Motorized Entrance Door Magnetic Holder

Bulletin Type:	SRP	Publication Date:	July 2022
Bulletin #(s):	22-064	Make(s):	Jayco & Entegra Coach
Job Code(s):	If affected unit has warranty	Model(s):	Seneca & Accolade
Flat Rate(s):	remaining, submit your claim following the normal process	Model Year(s):	2018-2022

Incident:	Motorized Entrance Door Opening During Transit	
Affected Units:	Certain 2018-2022 Jayco Seneca; 2018-2022 Entegra Coach Accolade	
Parts List:	N/A	
Misc. Tools & Supplies:	Philips screw driver Shims #10 x1.5"self-taping screws	
Parts Return Information:	N/A

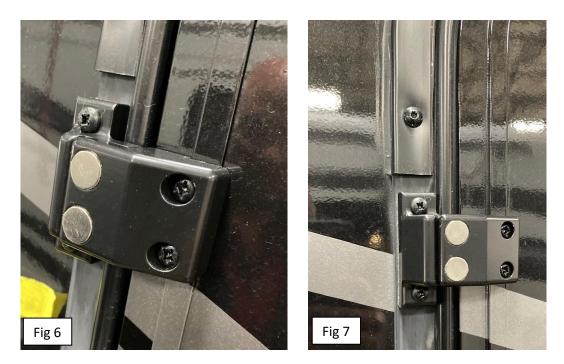
- 2. Insert shim between the two catches to allow for spacing during installation. (Figure 2)
- 3. Fasten catch on door first. Then use #10 x1.5" self-taping screw to screw.
 - a. Note: Start screw with screw gun and then finish snugging by hand to prevent any stripping.
